DEPARTMENT OF TRANSPORTATION
National Highway Traffic Safety Administration
Docket No. NHTSA-2010-0053
Visual-Manual NHTSA Driver Distraction Guidelines
For In-Vehicle Electronic Devices

ACTION: Notice of Federal guidelines.

This notice announces the issuance of the final version of the first phase of the NHTSA Guidelines. This first phase applies to original equipment (OE) in-vehicle electronic devices used by the driver to perform secondary tasks (communications, entertainment, information gathering, navigation tasks, etc. are considered secondary tasks) through visual-manual means (i.e., the driver looks at a device, manipulates a device-related control with his or her hand, and/or watches for visual feedback).

Figure 2: Drawing of Slide Presented by Toyota at NHTSA Technical Workshop¹³⁶

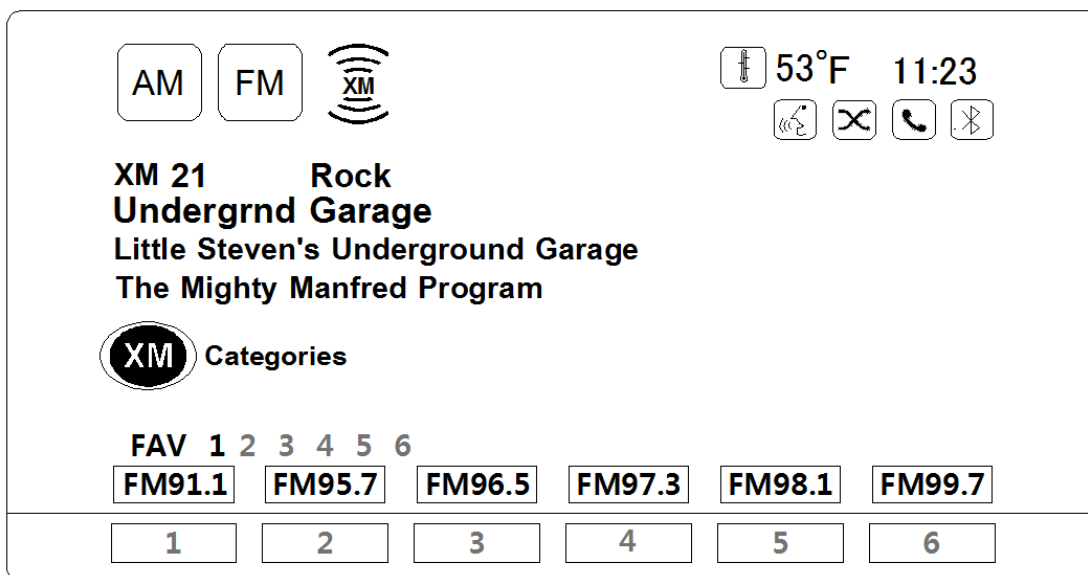
(See Figure 2 below). He then asked:

How do we apply the 30-character limit to this display? If it means a whole display can only contain 30 characters, if you look at just the six preset buttons, each preset button has five characters. So once we have the presets presented to the user, we can't give them any other information about what the radio is doing. If you pick any one element within this display, you quickly exceed a 30-character limit ...¹³⁵

Where should the 30 character limit be applied to this display?

Mr. Foley then pointed out that the information conveyed by this display is easily grasped and that drivers do not have to read each individual letter to understand what is being transmitted by this display.
